# MODIFICATION RECOMMENDATION FORM

MPID 254 : DSU FREQUENCY REQUIREMENTS

*RECOMMENDATION TO CER BY EIRGRID OF MODIFICATION TO GRID CODE.*

**RED-LINE VERSION**

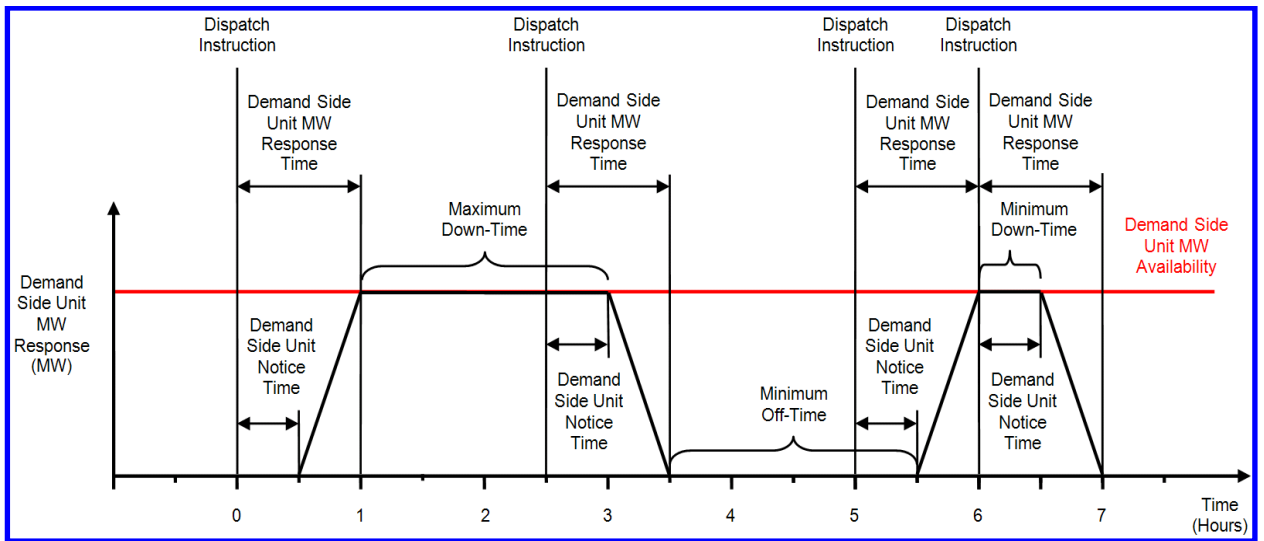
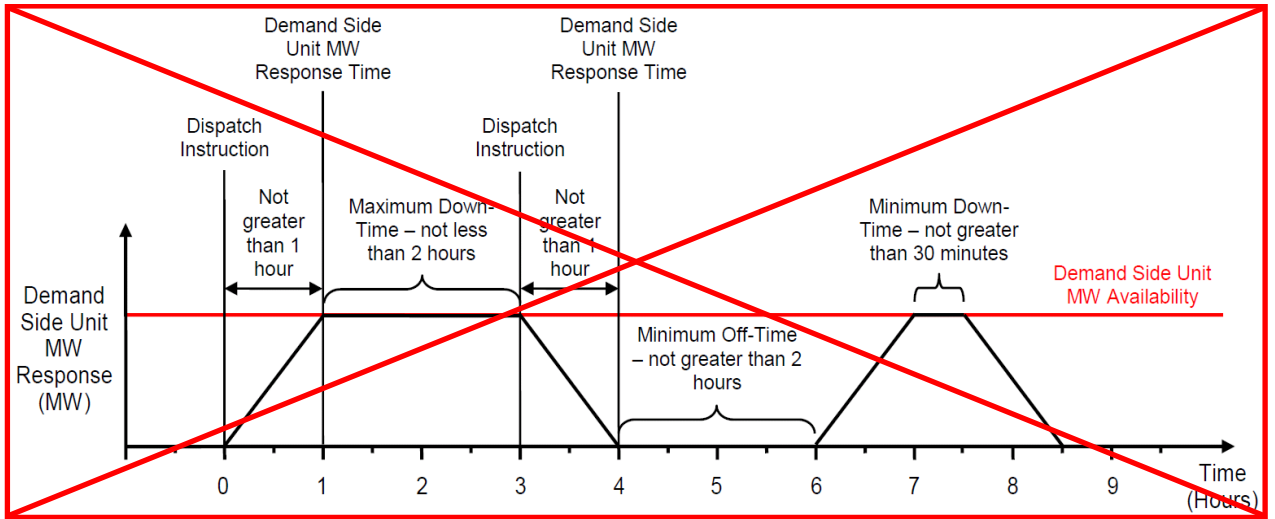
CC.7.4 Each **Demand Side Unit** shall, as a minimum, have the following capabilities:

- (h) maintain **Demand Side Unit MW Response at Transmission System Frequencies** in the range 49.5Hz to 50.5Hz;
- (i) maintain **Demand Side Unit MW Response at Transmission System Frequencies** within the range 47.5Hz to 49.5Hz and 50.5Hz to 52Hz for a duration of 60 minutes;

- (j) maintain **Demand Side Unit MW Response at Transmission System Frequencies** within the range 47.0Hz to 47.5Hz for a duration of 20 seconds required each time the **Frequency** is below 47.5Hz; and

- (k) maintain **Demand Side Unit MW Response** for a rate of change of **Transmission System Frequency** up to and including 0.5 Hz per second as measured over a rolling 500 milliseconds period.
